ADA Curb Ramp New Construction Inspection Form (Parallel)

Main	24952.54			Hillcrest
North-South Road Name	Project No.	Sheet No.	Intersection No.	East-West Road Name
Calibration Date 10/8/2024 (mm/dd/yy)

PARALLEL RAMP (PL)

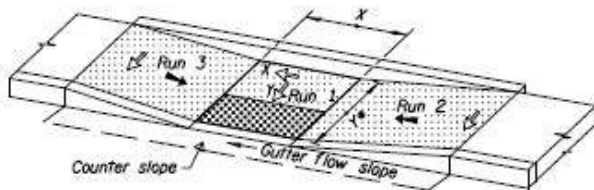
RAMP RUN 1	Pass	Fail
Running Slope 1	<input type="text" value="5.9"/> $\leq 2.0\%$ <input type="checkbox"/> $> 2.0\%$ <input type="checkbox"/>	<input type="checkbox"/>
Cross Slope 1	<input type="text" value="5.9"/> $\leq 2.0\%$ <input type="checkbox"/> $> 2.0\%$ <input type="checkbox"/>	<input checked="" type="checkbox"/>
Detectable Warning	<input type="text" value="Y"/> Y <input checked="" type="checkbox"/> N <input type="checkbox"/>	<input type="checkbox"/>
Lip Height	<input type="text" value="0"/> $\leq 1/4"$ <input checked="" type="checkbox"/> $> 1/4"$ <input type="checkbox"/>	<input type="checkbox"/>
Gutter Flow Slope	<input type="text" value="4.5"/> $\leq *$ <input type="checkbox"/> $> *$ <input type="checkbox"/>	<input type="checkbox"/>
Curb Running Slope (avg)	<input type="checkbox"/> <input type="text" value="6.64"/> $\leq 8.3\%$ <input checked="" type="checkbox"/> $> 8.3\%$ <input type="checkbox"/>	<input type="checkbox"/>

Counter Slope (+/-)*2	<input type="text" value="8.3"/> $\leq 5.0\% $ <input type="checkbox"/> $> 5.0\% $ <input checked="" type="checkbox"/>	<input type="checkbox"/>
Det. warning full width of ramp	<input type="text" value="Y"/> Y <input checked="" type="checkbox"/> N <input type="checkbox"/>	<input type="checkbox"/>

RAMP RUN 2	Pass	Fail
Running Slope 2	<input type="text" value="10.6"/> $\leq 8.3\%$ <input type="checkbox"/> $> 8.3\%$ <input checked="" type="checkbox"/>	<input type="checkbox"/>
Length 2	<input type="text" value="7.8"/>	
Cross Slope 2	<input type="text" value="7.8"/> $\leq 2.0\%$ <input type="checkbox"/> $> 2.0\%$ <input type="checkbox"/>	<input type="checkbox"/>

RAMP RUN 3	Pass	Fail
Running Slope 3	<input type="text" value="12.5"/> $\leq 8.3\%$ <input type="checkbox"/> $> 8.3\%$ <input checked="" type="checkbox"/>	<input type="checkbox"/>
Length 3	<input type="text" value="12.5"/>	
Cross Slope 3	<input type="text" value="12.5"/> $\leq 2.0\%$ <input type="checkbox"/> $> 2.0\%$ <input type="checkbox"/>	<input type="checkbox"/>

TURN SPACE	Pass	Fail
Width X	<input type="text" value="5.0"/> $\geq 4.0'$ <input checked="" type="checkbox"/> $< 4.0'$ <input type="checkbox"/>	<input type="checkbox"/>
Length Y	<input type="text" value="6.1"/> $\geq 4.0' * 1$ <input checked="" type="checkbox"/> $< 4.0' * 1$ <input type="checkbox"/>	<input type="checkbox"/>
Back of Ramp Obstruction (Y/N)	<input type="text" value="N"/> $\geq 5.0' * 1$ <input type="checkbox"/> $< 5.0' * 1$ <input type="checkbox"/>	<input type="checkbox"/>
Slope X (Cross Slope 1)	<input type="text" value="5.9"/> $\leq 2.0\%$ <input type="checkbox"/> $> 2.0\%$ <input checked="" type="checkbox"/>	<input type="checkbox"/>
Slope Y (Running Slope 1)	<input type="text" value="5.9"/> $\leq 2.0\%$ <input type="checkbox"/> $> 2.0\%$ <input type="checkbox"/>	<input type="checkbox"/>

MISCELLANEOUS	Pass	Fail
Clear Width (feet)	<input type="text" value="5.0"/> $\geq 4.0'$ <input type="checkbox"/> $< 4.0'$ <input type="checkbox"/>	<input type="checkbox"/>
Intersection Control Type	<input type="text" value="SY"/> Slope of Rd. <input type="text" value="4.3"/>	
Horizontal Gaps	<input type="text" value="No"/> $\leq 1/2"$ <input type="checkbox"/> $> 1/2"$ <input type="checkbox"/>	<input type="checkbox"/>

IITD gt2. R3 asphalt
